STEREO IMPACT SEP TOP LVPS FM1 REWORK INSTRUCTIONS

STEREO IMPACT SEP LVPS TOP BOARD

Figure 1:

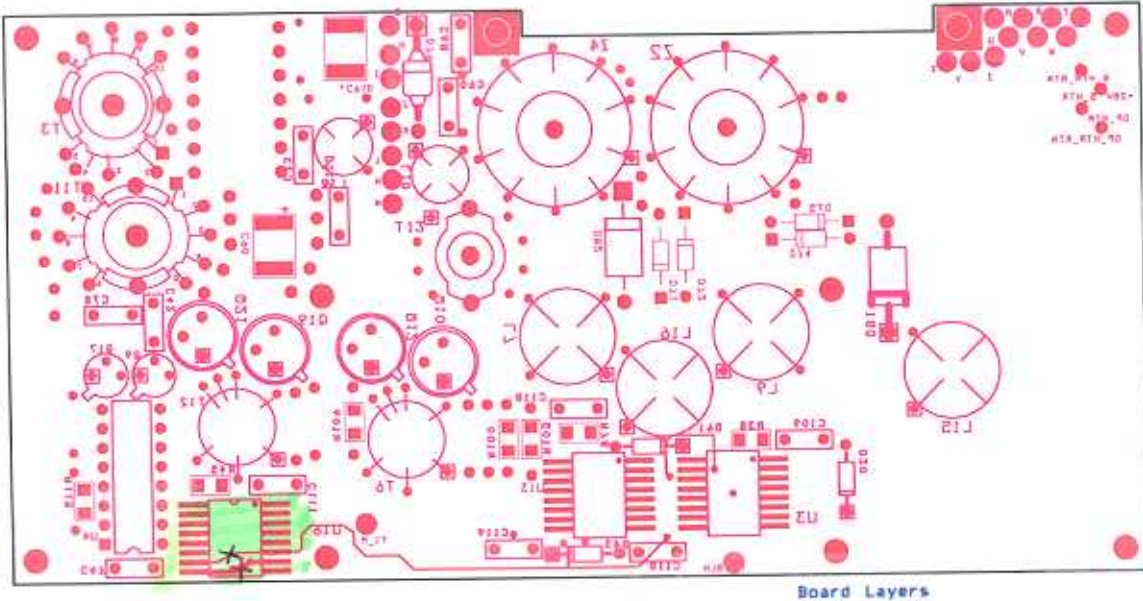
SEP TOP board has a short between U16 Pin 6 and U16 Pin 10 due to schematic generating software error where two separate signal lines were named the same. In order to separate the signals, four traces need to be cut.

- 1) Cut the trace between U16 pin 6 and U16 pin 10. (See Layout Figure 1)
Completed by _____ Date _____
- 2) Cut the trace between U29 Pin 9 to the via (See Layout Figure 2)
Completed by _____ Date _____
- 3) Epoxy the traces that were cut.
Completed by _____ Date _____
- 4) Replace any parts that needed to be removed in order to cut the traces. Record the reference designator and the new date code below.
